Comment Resolution Status

Document: T10/01-328r5

To: T10 Committee Membership
From: Cris Simpson, Intel Corporation
Subject: Response to T10 Letter Ballot comments on SRP

This document contains **T10/1415-D revision 13**, the SRP Working Draft.

Figure 0.1 - IB I/O unit example

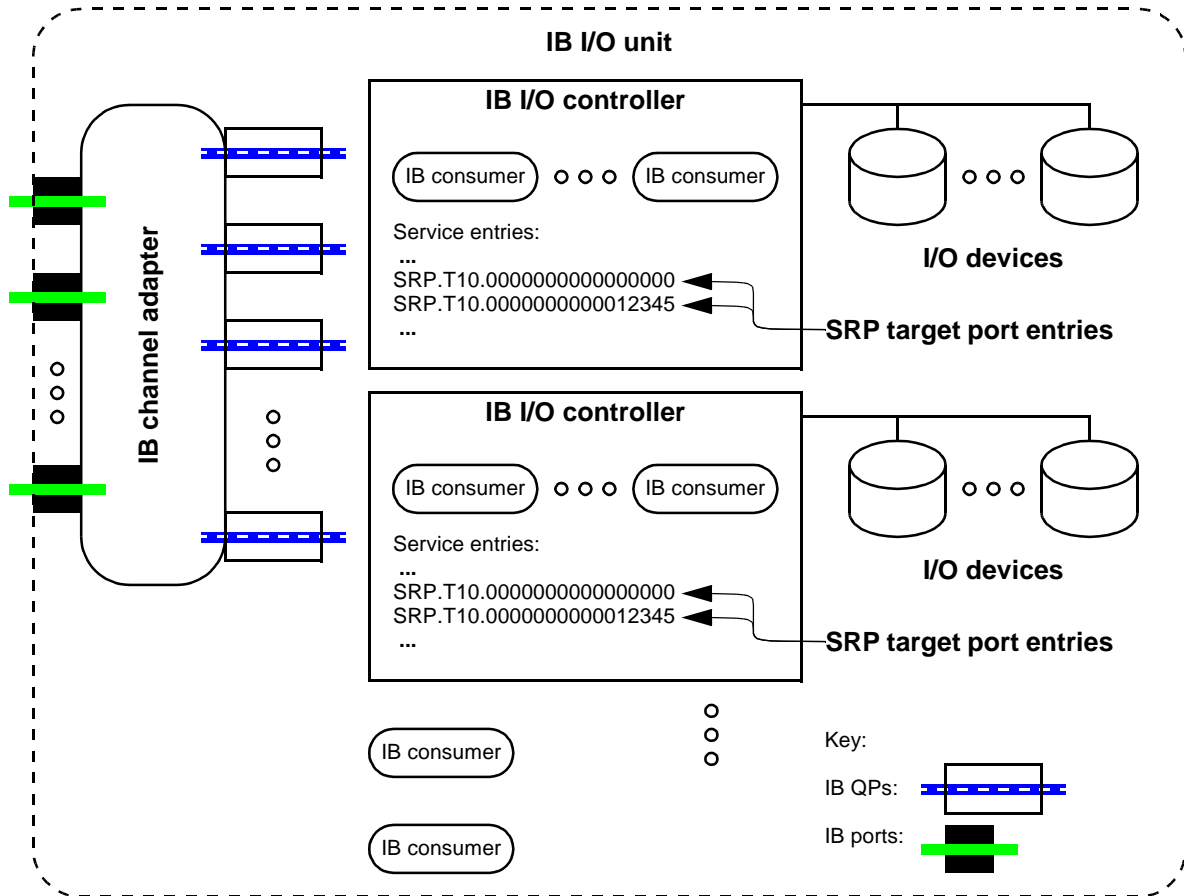
Figure B.3's equating of 'SRP Target Ports' with 'IB consumers' is problematic. A 'target port' is a sort of service access point---somewhere where interested parties initially go to obtain service, but without any implication that that's where the service is actually provided. (In IB, it's the Connection Manager that receives the initial connection request, interprets the ServiceID contained therein, and performs some magic that results in the instantiation of a QP bound to some entity that actually provides the target services). This target-services-providing entity fits the definition of 'IB consumer'. But the mapping of ServiceIDs-cum-SRP target ports onto such entities is clearly a matter of implementation, and could be one-to-many, many-to-one, or many-to-many Suggested Solution: One possibility: to the left of the IB Consumers show a table/list of service IDs within each IB I/O unit and label these entries as SRP Target Ports; use arrows to show a mapping from the entries to the IB Consumers, with e.g. one Consumer mapped to two IDs and another mapped to one ID to show that the mappings are not always 1 to 1. A further refinement might be to use another set of arrow between the Consumers and the QPs to show that the this mapping is also not 1 to 1

Notes from 28 Nov 2001 teleconference: show service entries in figures B.2 and B.3, in accompanying text explain that each service entry identifies an SRP target port.

This comment is correct, but it's not immediately obvious how to incorporate it into a legible diagram. Note the further complication introduced by connection redirection. The IB consumer (IB QP and the software, etc. behind it) may be in an unrelated device / node / whatever, it need not be the same channel adapter or even an I/O unit. The sole purpose of the I/O unit and I/O controller is to obtain a service ID, connecting to that service ID may lead somewhere else altogether.

The following is an attempt at a modified figure B.2 and the text describing service entries that identify SRP target ports

One or more service entries are associated with each IB I/O controller. A service entry contains a name and other information identifying an individual service provided by the IB I/O controller. A service entry may identify an SRP target port or a non-SRP service (e.g. a network interface service). Requirements for service entries that identify SRP target ports are described in table B.8.

Figure 1 - SCSI document relationships

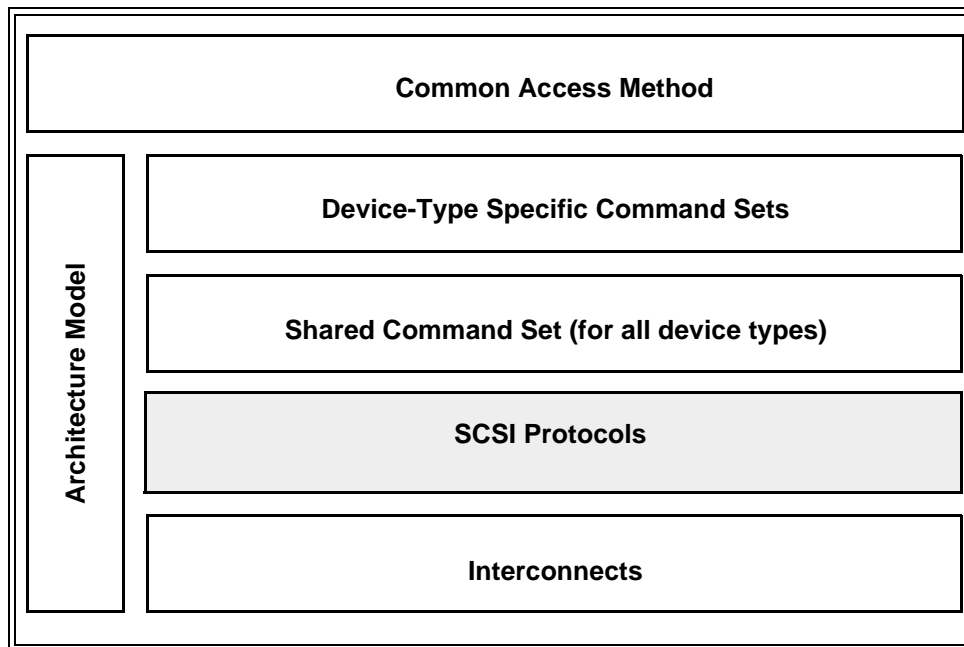
Delete CAM from figure 1 Delete these SCSI-2 standards from the example standards list:
Serial Storage Architecture SCSI-2 Protocol SSA-S2P [ANSI X3.294:1996] Common Access Method: SCSI Common Access Method CAM [ISO/IEC 9316-421] [ANSI X3.232:1996]
The 28 Nov 2001 teleconference voted that this be accepted.

"Figure 1 shows the relationship of this standard to the other standards?" But it doesn't. The SRP standard is not identified in the figure. Despite the disclaimer, layering of the blocks does suggest a hierarchy, protocol stack and system architecture. But the figure does not indicate the applicability of SRP to the implementation of a SCSI transport, as far as I can tell.

Figure 4 - Memory descriptor mapping

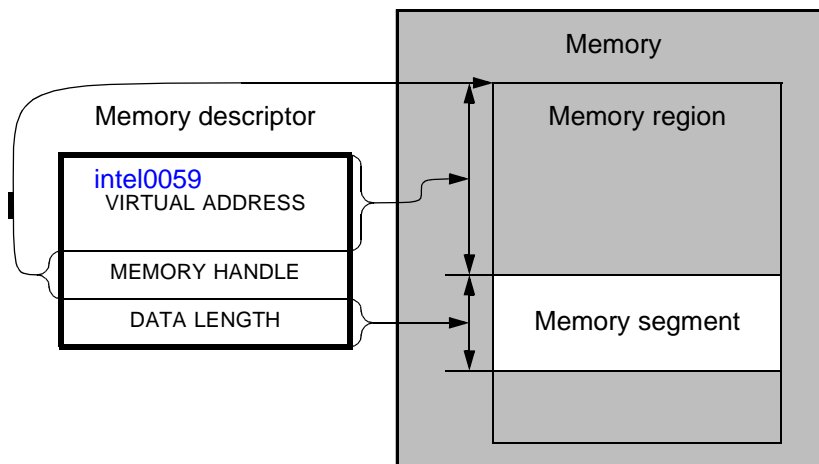
Page 17 - Figure 4 - The way the arrows are pointing for the virtual address implies that it is not the address of the first byte of the memory segment. It currently implies that it is the space from the memory handle to the beginning of the memory segment which is the memory region. It is also not clear as to what the boundaries are of the memory region. The current drawing implies it is only the area above the memory segment. I do not believe that is correct so it needs to be fixed.

Figure A.2 - Model for a four step confirmed service

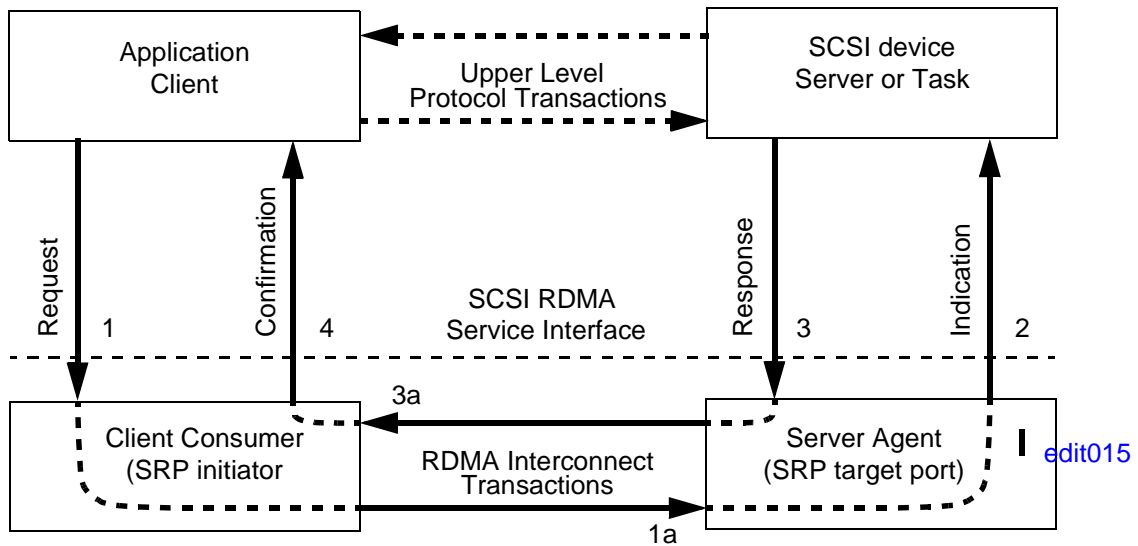
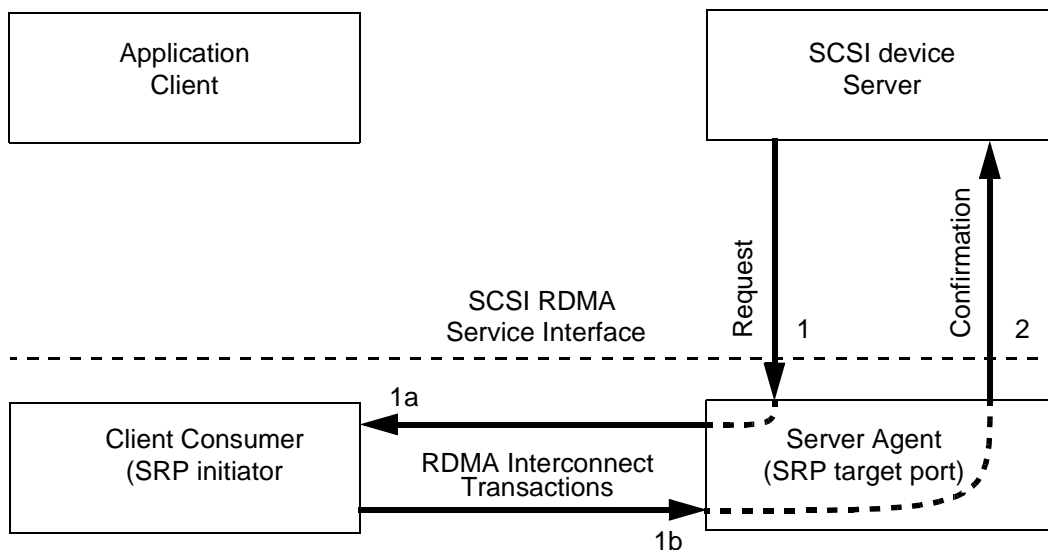
Page 46 - figure A.2 and A.3 - line 15 and 43 - The statement '(SRP initiator' should be '(SRP initiator port)'

Figure B.2 - IB I/O unit example

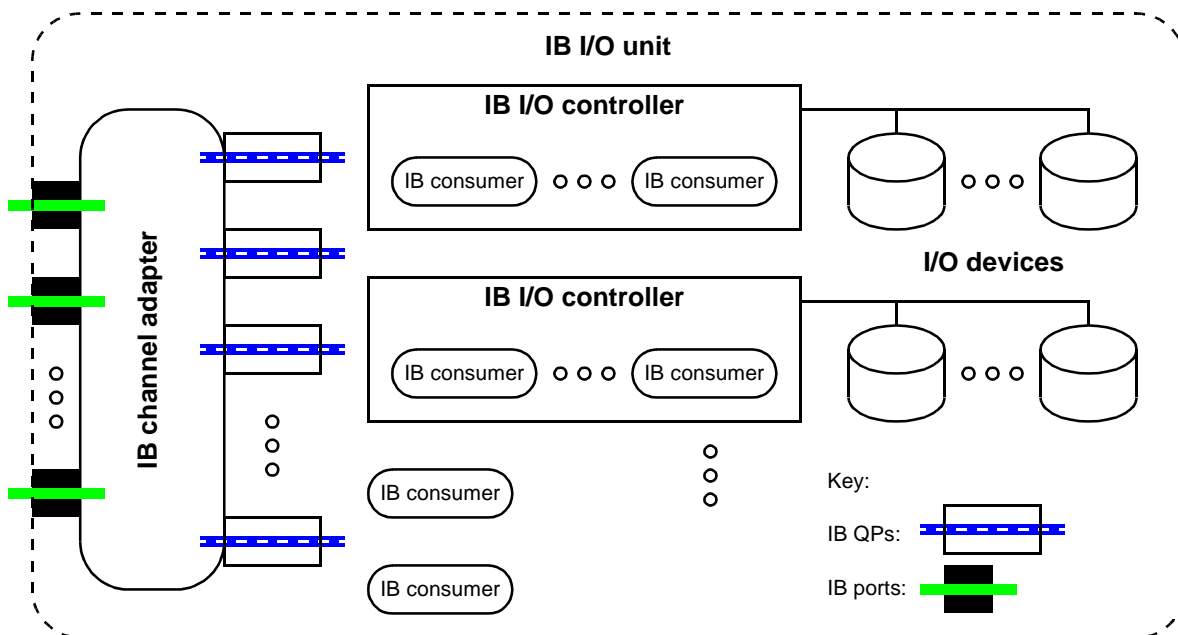
Figure B.2. Can I/O controllers be virtual objects?

Figure B.2. What is the purpose of allowing multiple IB consumers per IB I/O controller? Is it so that multiple IB connections can be terminated within an IB I/O controller? (This relates to the question above about correspondence between QPs and IB consumers.)

Figure B.2. How are shared LUs modeled? Do SRP target ports contain the "task router" function described recently by Penokie? Can two IB I/O controllers have an underlying LU in common, or is this functionality restricted to two IB consumers within the same IB I/O controller?

Figure B.3 - SCSI architecture mapping

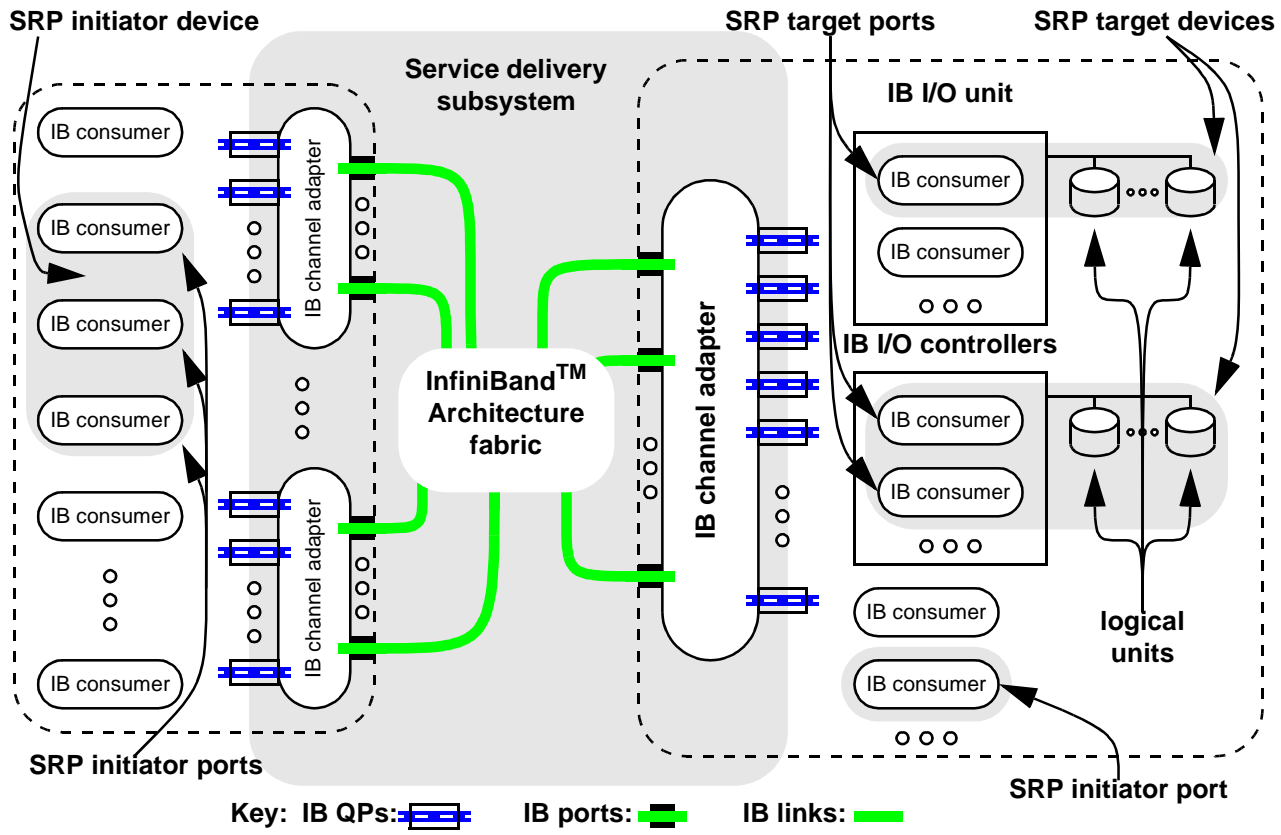
Figure B.3. What is the object indicated by the dashed lines in the initiator model, analogous to the IB I/O unit in the target model?

Figure B.3. and 56-1. Table B.2. The rules for constructing initiator ports seem entirely too lax. The text says, "Initiator port identifier should be constructed?" And then the Table indicates that GUID, for example, is the channel adapter GUID. Is there no meaning associated with the initiator port ID? Is the only design goal that the 16B port ID be globally unique? Will any GUID do at all? If so, let's be explicit about this, and **let's not make any suggestions about the origin (and possible meaning) of the port name.**
